Item ID: D206-667-203 Accept ***N900040100*** Setup Start ***NS1***
 Revision ID: Stop ***NS2***
 Item Name: Aft Crosstube - High 206L / L1 / L3 / L4
 Start Date: 7/6/2015 Start Qty: 1.00 ***1*** Cust Item ID:
 Required Date: 7/6/2015 Req'd Qty: 1.00 ***1*** Customer:
 Reference:

DART AEROSPACE LTD		Work Order:	134199
Description: Crosstube High Aft (206L)		Part Number:	D206-667-203
Inspection Dwg: D206-667-243	Rev: C	Page 1 of 1

DRAWING NO. D206-667-243	TITLE CROSSTUBE ASS'Y (206L HIGH AFT)	REV. C	DART AEROSPACE LTD ENGINEERING ORDER		D.E.O. NO. D206-667-243-C-1	SHEET NO. SHEET 1 OF 1	SCALE NTS
DRAWN 90	CHECKED ADS	MFG. APPR. RB	APPROVED MP		DE APPR. H		
DATE 11.07.15	DATE 11.07.20	DATE 11.07.21	DATE 11/07/21		DATE 11.07.21

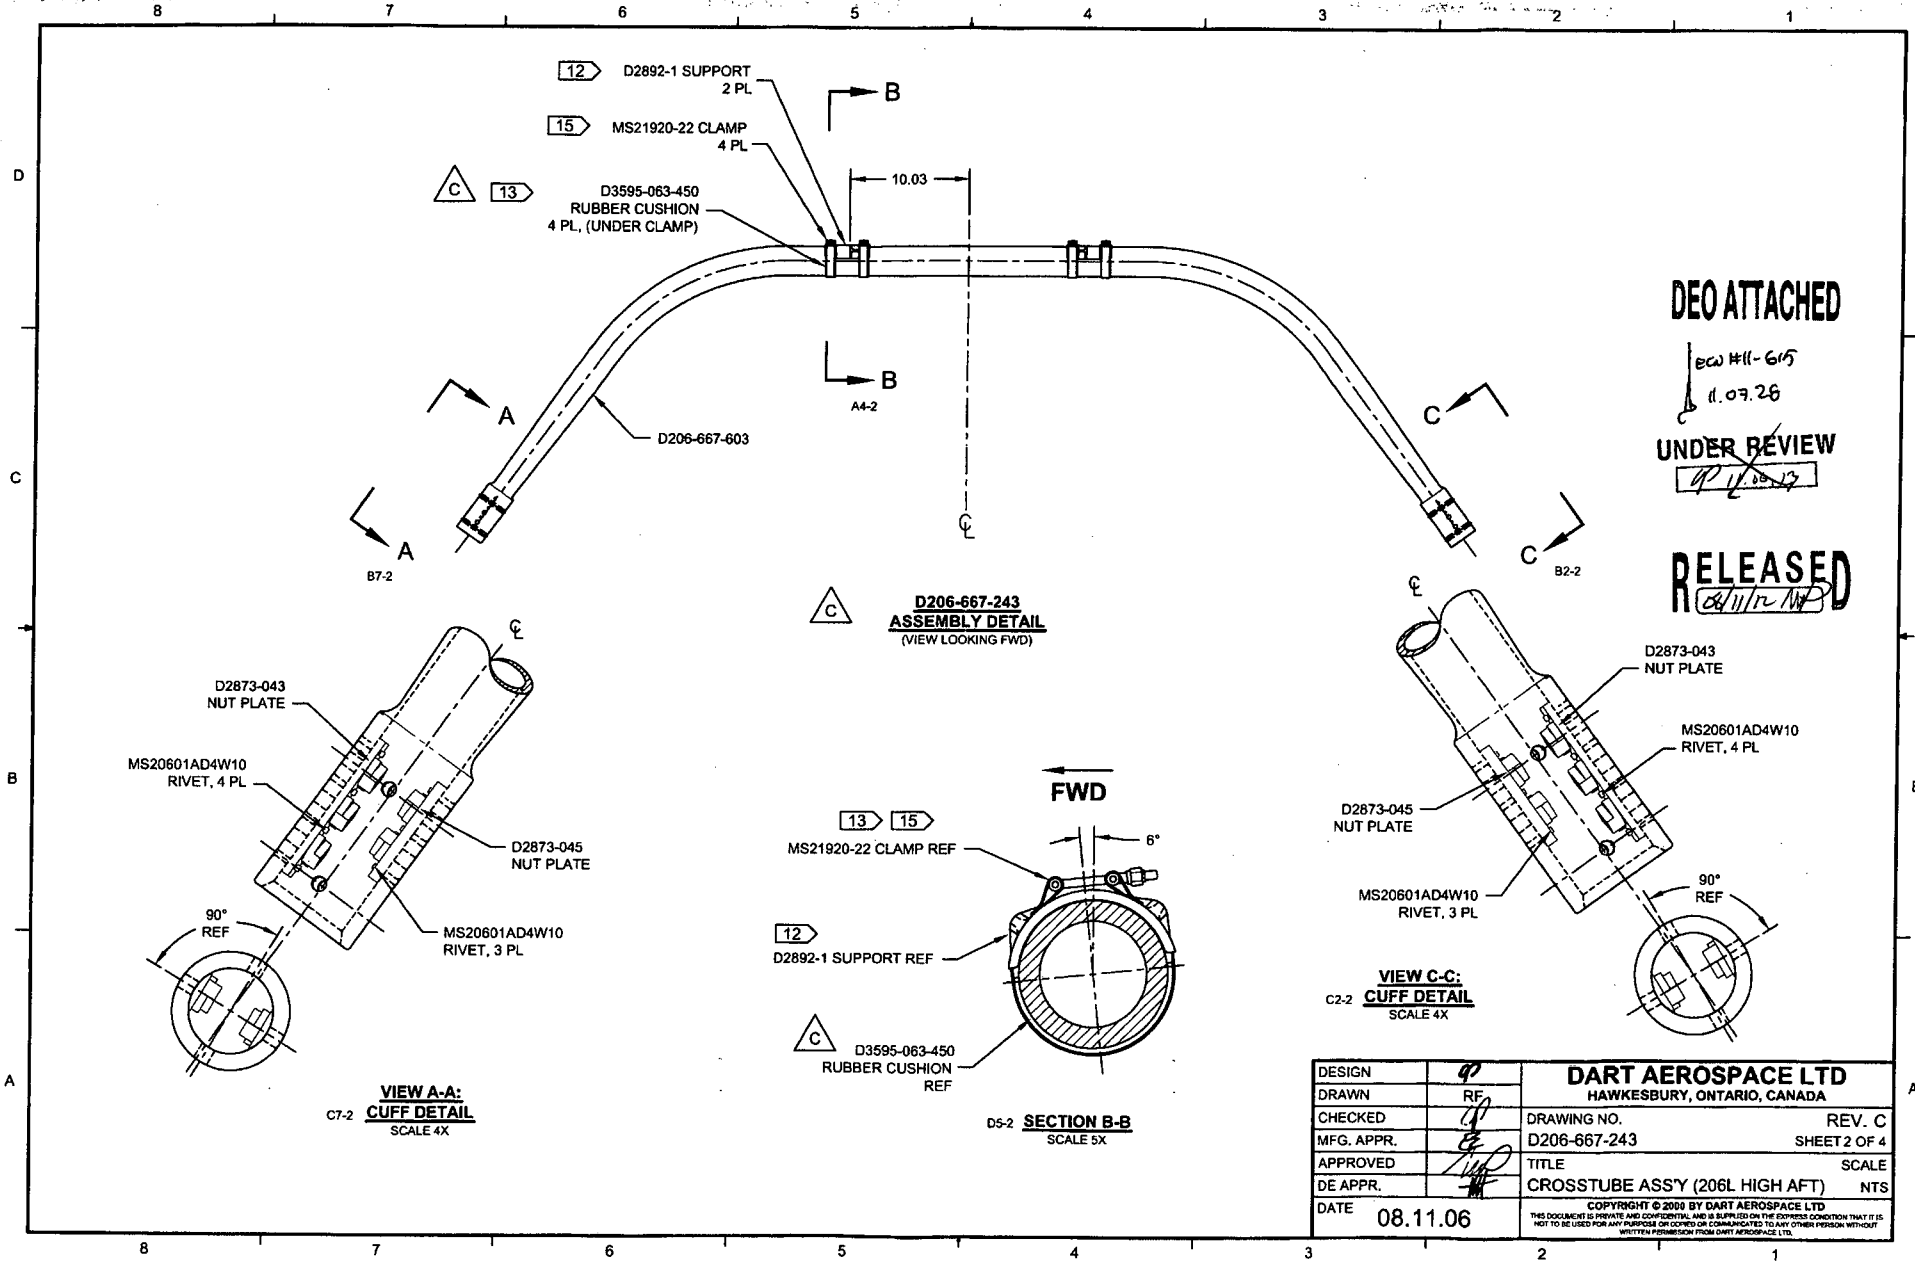
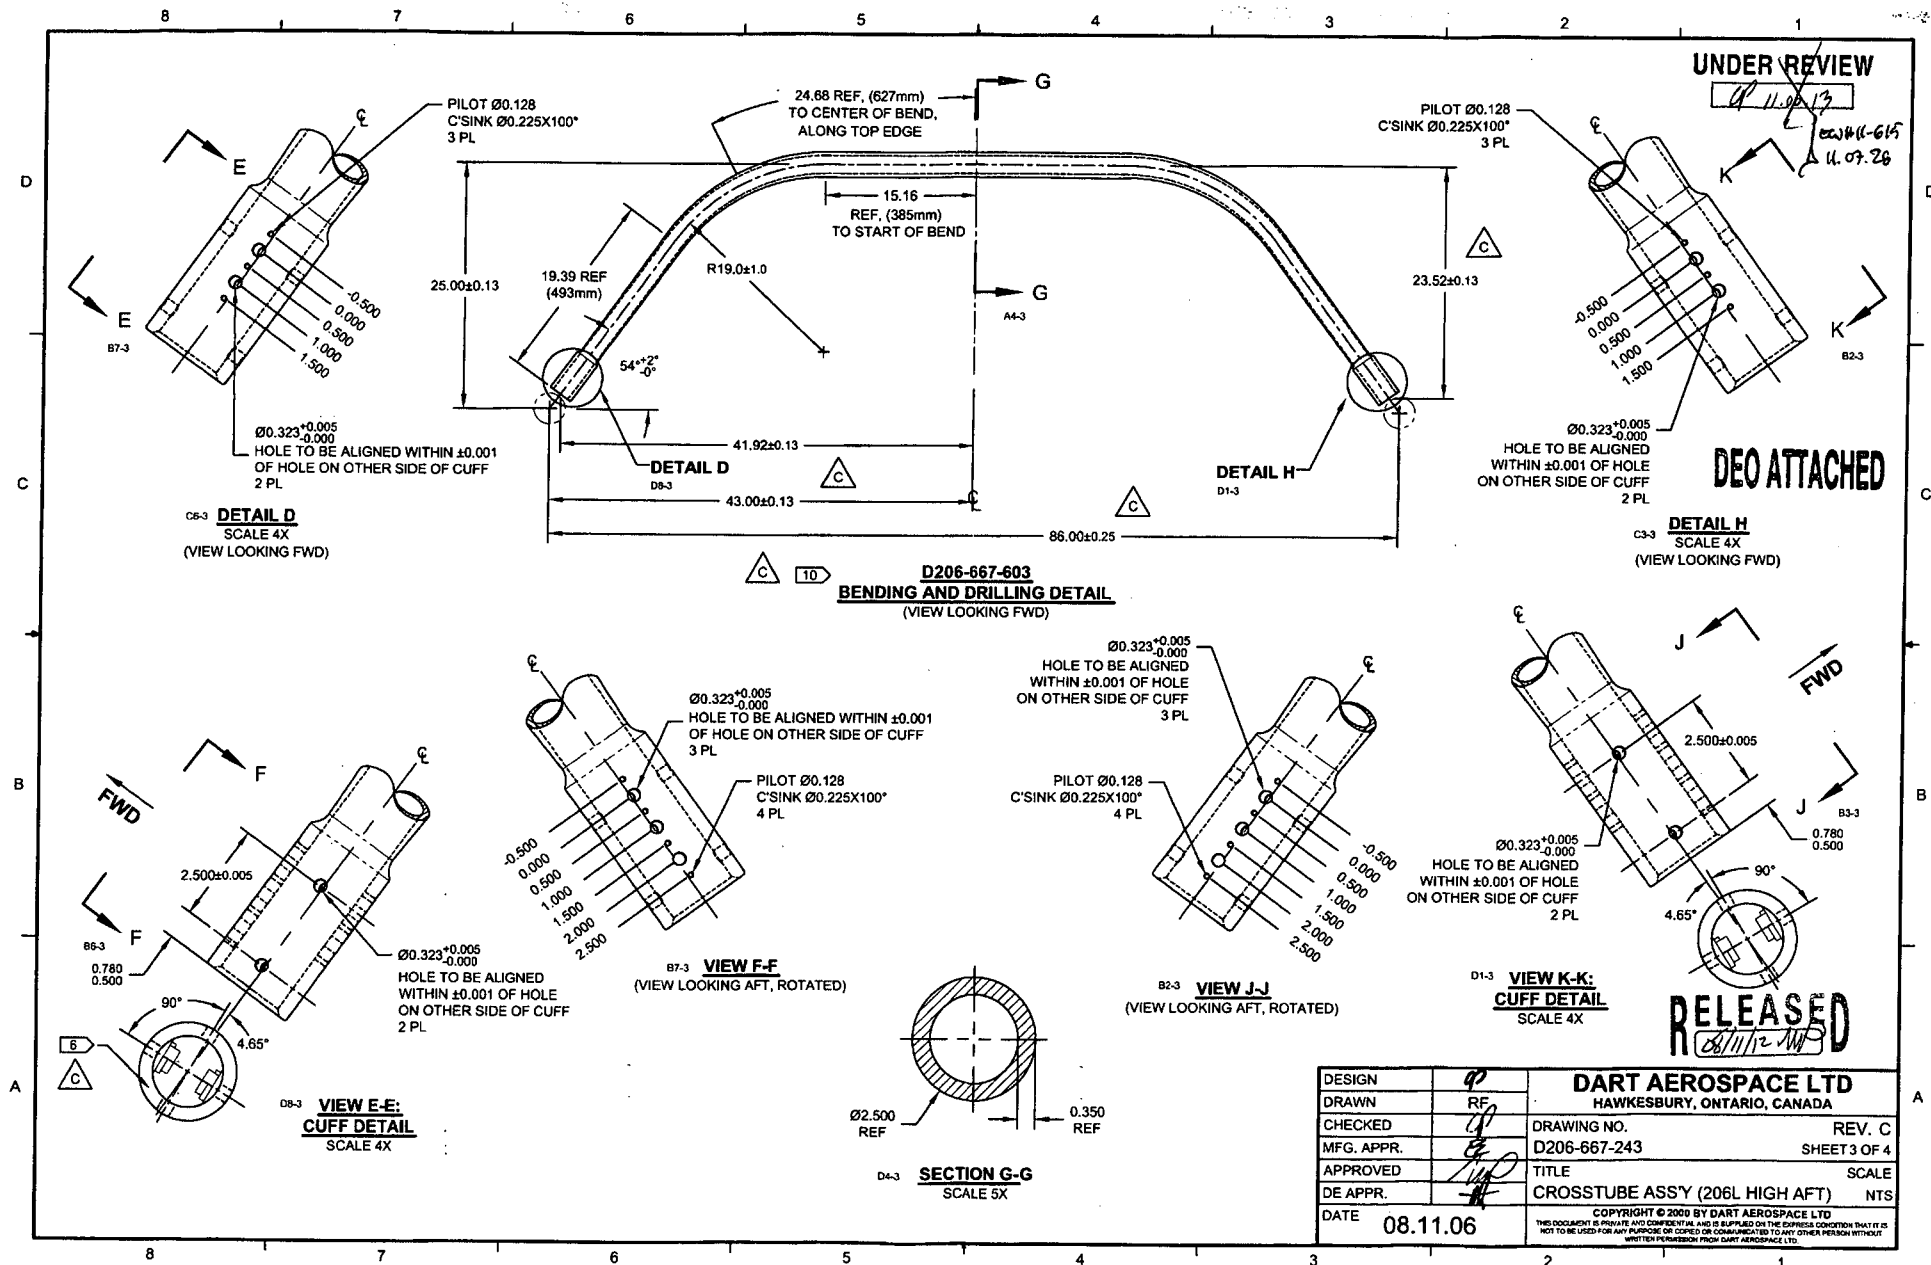
PURPOSE:

REPLACE MAGNOBOND WITH PROSEAL.

NOTE 12 & 15, SHEET 1 IS AMENDED AS FOLLOWS:

IS:

- 12) TO INSTALL D2892-1 SUPPORT: ABRABE MATING SURFACE OF SUPPORT AND CROSSTUBE WITH 180-GRIT SANDPAPER AND REMOVE RESIDUE WITH MEK (OR EQUIVALENT). APPLY A 0.04" TO 0.07" THICK LAYER OF PROSEAL 890 CLASS B-2 (OR AMS-S-8802 CLASS B-2) SEALANT TO MATING SURFACE OF SUPPORT.
- 15) TORQUE CLAMPS 80 TO 100 IN-LB. ENSURE AT LEAST 1.5 THREADS SHOWING IN SAFETY AND THAT NUT HAS NOT BOTTOMED-OUT AFTER TORQUING. **PRIOR TO PACKAGING, RE-CHECK TORQUE ON CLAMPS AFTER PROSEAL 890 SEALANT HAS CURED FOR 72 HOURS.**

WAS:

- 12) INSTALL D2892-1 SUPPORT USING 0.03" TO 0.06" THICK LAYER OF MAGNOBOND 6398 PER QSI 015. LET CURE FOR 12 HOURS AFTER INSTALLATION AND PRIOR TO PACKAGING.
- 15) TORQUE CLAMPS 80 TO 100 IN-LB. ENSURE AT LEAST 1.5 THREADS SHOWING IN SAFETY AND THAT NUT HAS NOT BOTTOMED-OUT AFTER TORQUING.
